City of Phoenix
PLANNING AND DEVELOPMENT DEPARTMENT

Subject: ITEMS 59, 60 & 61 ON THE FEBRUARY 3, 2021 FORMAL AGENDA – PUBLIC HEARING/ORDINANCE ADOPTION OF Z-26-20-7 (G-6806), Z-TA-5-20-7 (G-6807) & HISTORIC PRESERVATION CONSERVATION EASEMENT RELEASE OF ARIZONA OIC- – SOUTHWEST CORNER OF 1ST AND JACKSON STREETS

Exhibit B: Proposed Downtown Code Building Height Map dated February 1, 2021

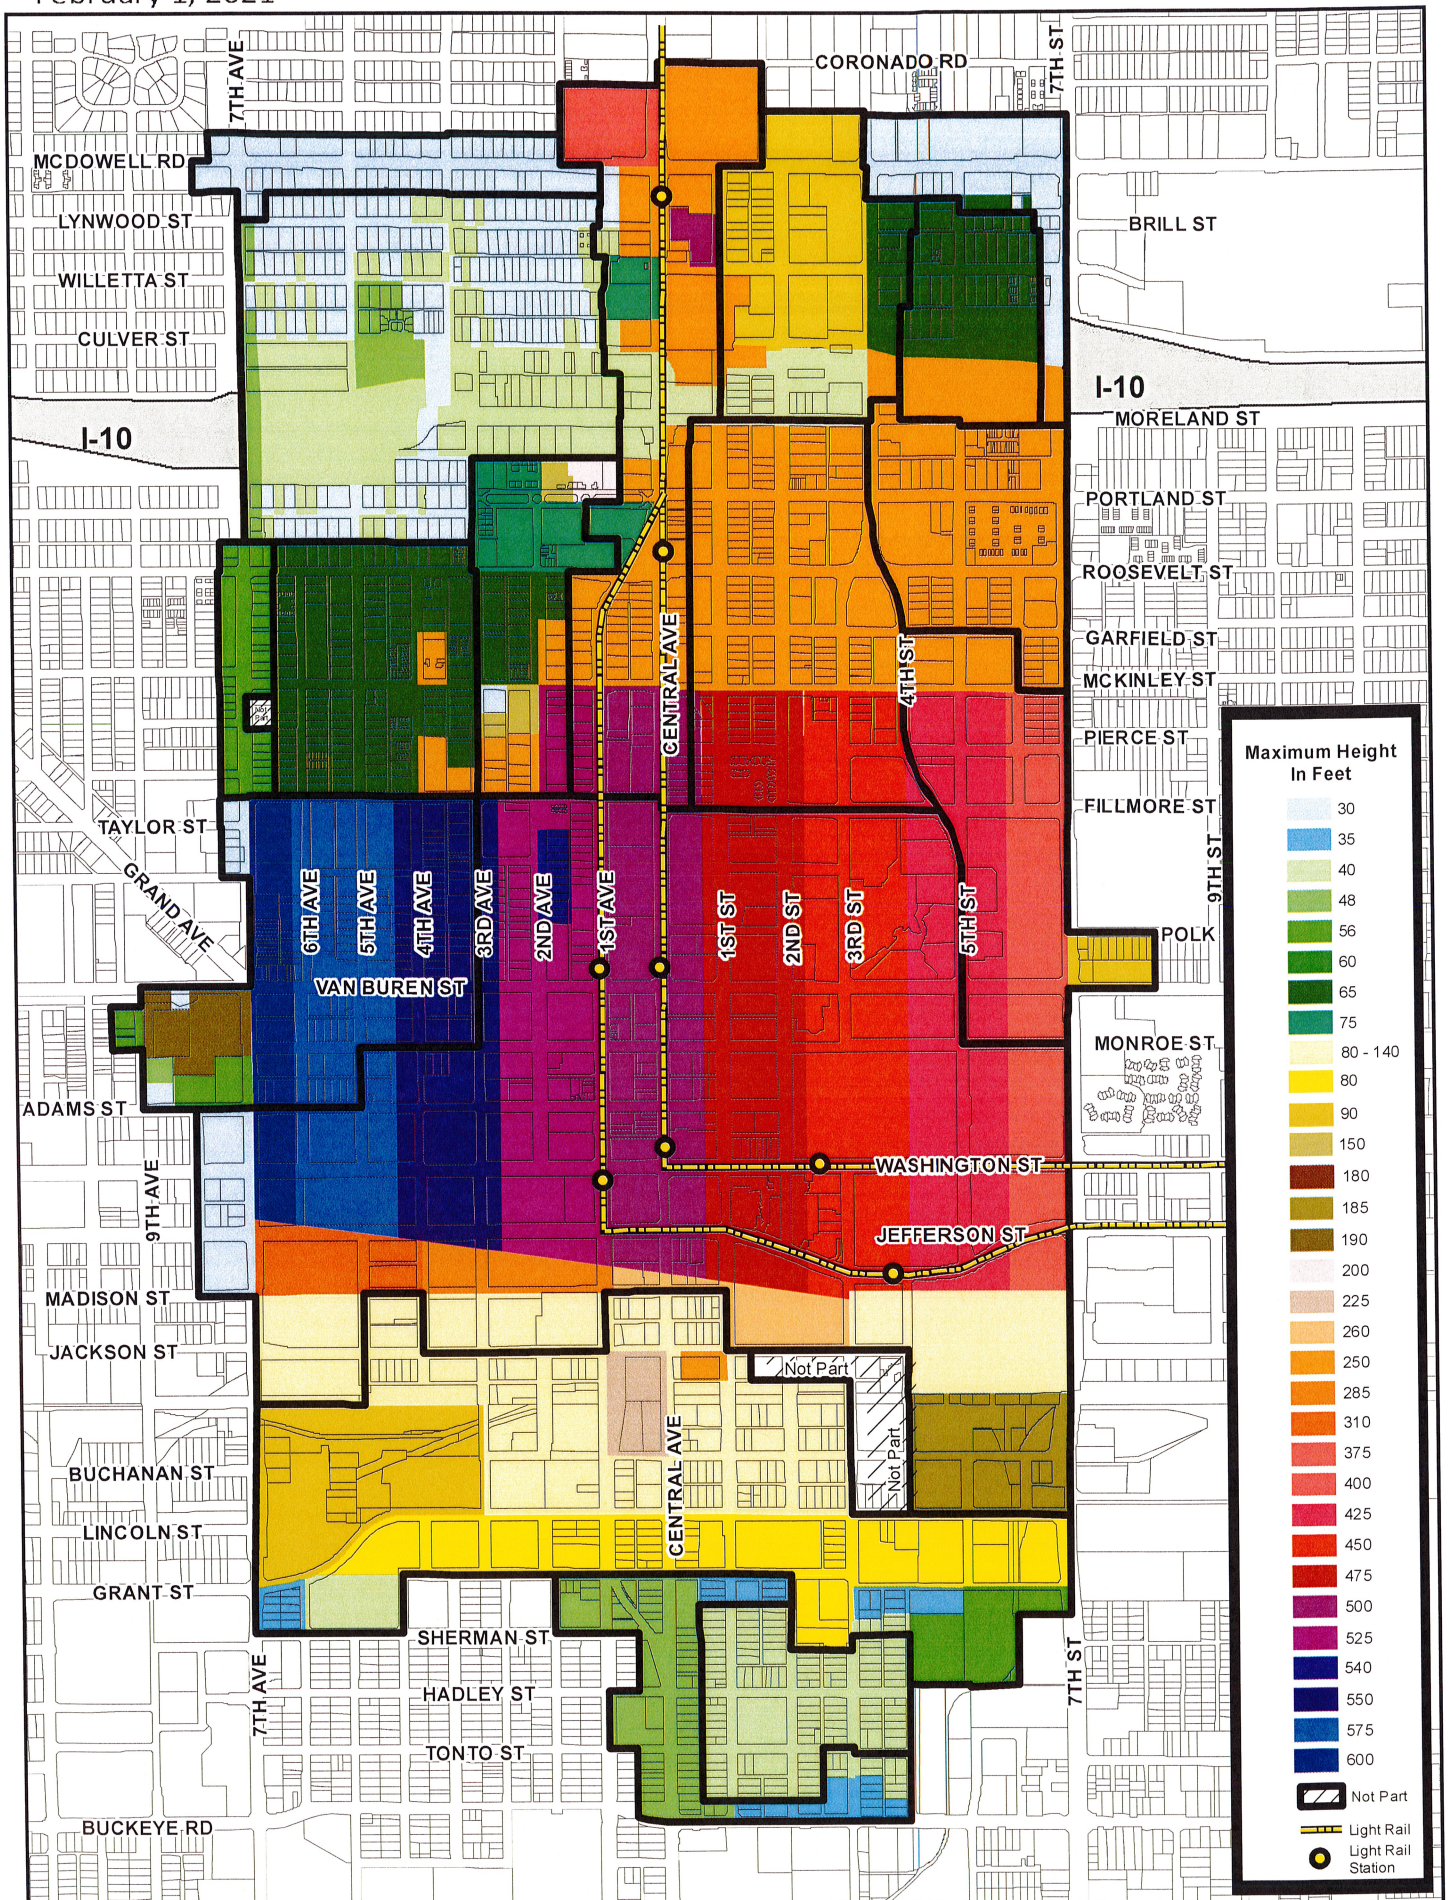
The proposed maximum building height increase for the site on the Downtown Code's Building Height Map (285) conflicts with the maximum building height permitted in Chapter 4 of the Phoenix City Code. The applicant is proposing to modify the proposed text amendment to the Downtown Code Height Map to limit the maximum height on the site to 250 feet. In addition, staff is recommending that language be added to the map to reiterate the City Code provision that states should a conflict exist between the City Code building height limitations and the Downtown Code Building Height Map the lower limitation shall apply. An updated version of the map is attached to this memo.

WHERE THERE EXISTS A CONFLICT BETWEEN THE HEIGHT LIMITATION PRESCRIBED IN THE CHAPTER AND ANY OTHER REGULATIONS IN CHAPTER 4 OF THE PHOENIX CITY CODE, THE LOWER LIMITATION SHALL GOVERN AND PREVAIL. (SEE PHOENIX CITY CODE SEC. 4-247)
